MELBOURNE METRO RAIL PROJECT ENVIRONMENT EFFECTS STATEMENT
INQUIRY AND ADVISORY COMMITTEE

MMRA TECHNICAL NOTE

TECHNICAL NOTE NUMBER: 054

SUBJECT: Response to David Anderson’s Request for Further Information

Figure 1: Indicative location of Chiller Plant and its proximity to noise sensitive receivers.

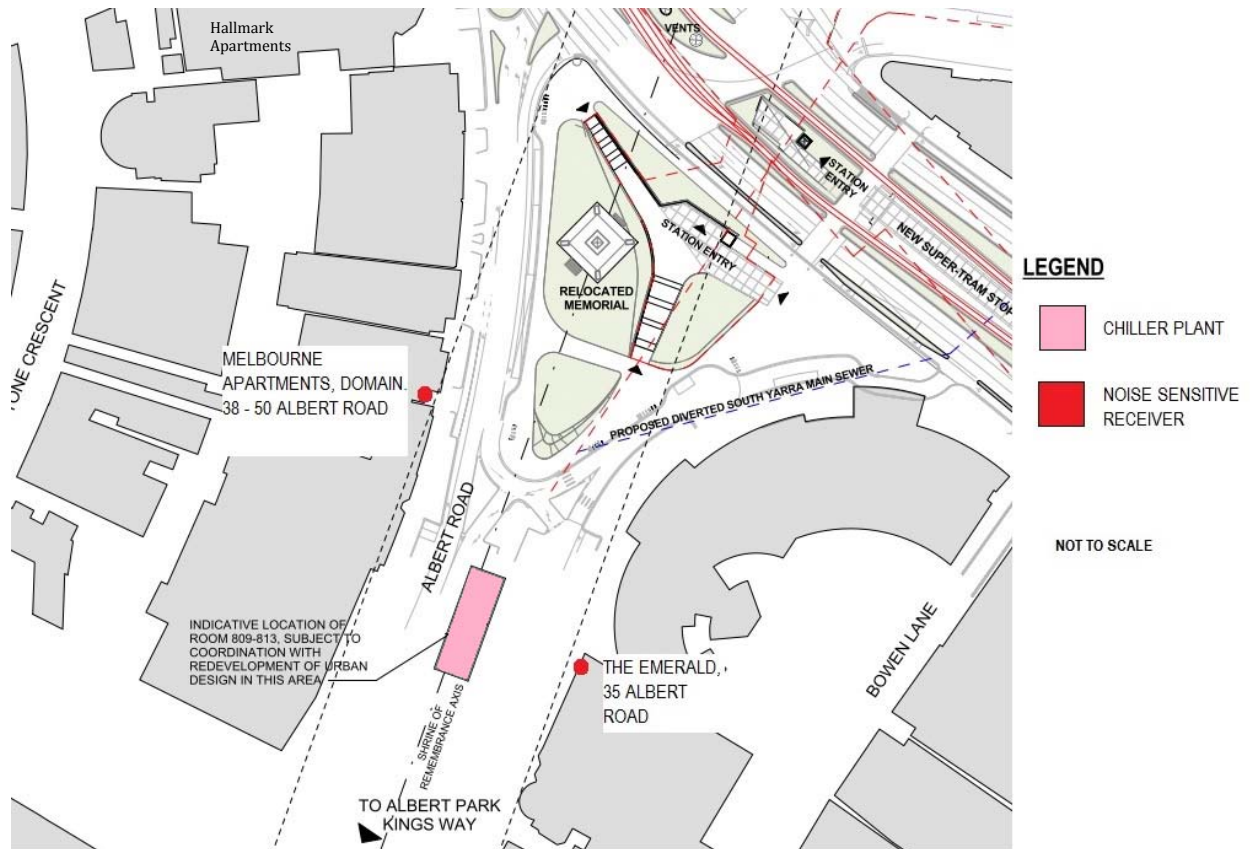
1. In the course of preparing his Expert Witness Statement, Mr David Anderson requested further information concerning the scope to ameliorate noise from chiller plants associated with the proposed station structures.
2. This technical note responds to that request.

- Appendix D to the NVIA identifies that a chiller plant may be located within the road reserve of Albert Road (see Table D.1 of the NVIA). This is consistent with the location identified by MMRA in Technical Note 015 as a potential location for service structures associated with the Domain Station (i.e. within the road reserve of Albert Road south of the station box). However, it should be noted that the final location of the chiller plant remains to be determined.
- For the purposes of this assessment, the indicative chiller plant location is shown in Figure 1 and is located away from other fixed infrastructure associated with the Melbourne Metro.

16. The levels predicted would comply with the day period noise limit but exceed the night period noise limit (limits as shown in Table 2).
17. Mitigation measures would accordingly be required in order to achieve compliance with SEPP N-1 (and with EPR NV16).
18. In this case suitable measures would comprise acoustic louvres (600mm in depth) to enclose the entire plant (eg for surrounding walls and over the top forming a roof) to prevent any direct line of sight between the chillers and the noise sensitive areas (high rise residential towers).
19. The acoustic louvre would be designed to comply with the following performance criteria.

20. Upon the installation of these louvres, the predicted noise levels at the residential receivers (Table 6) attributable to the indicative chiller plant would comply with all relevant noise limits.

23. The proposed use of acoustic louvres for surrounding walls and roof of the chiller plant would allow sufficient airflow around the chiller plant for the plant to operate efficiently. The footprint of the proposed design allows for the louvres to be located a sufficient distance from the chiller plant to allow appropriate circulation around the chiller plant.
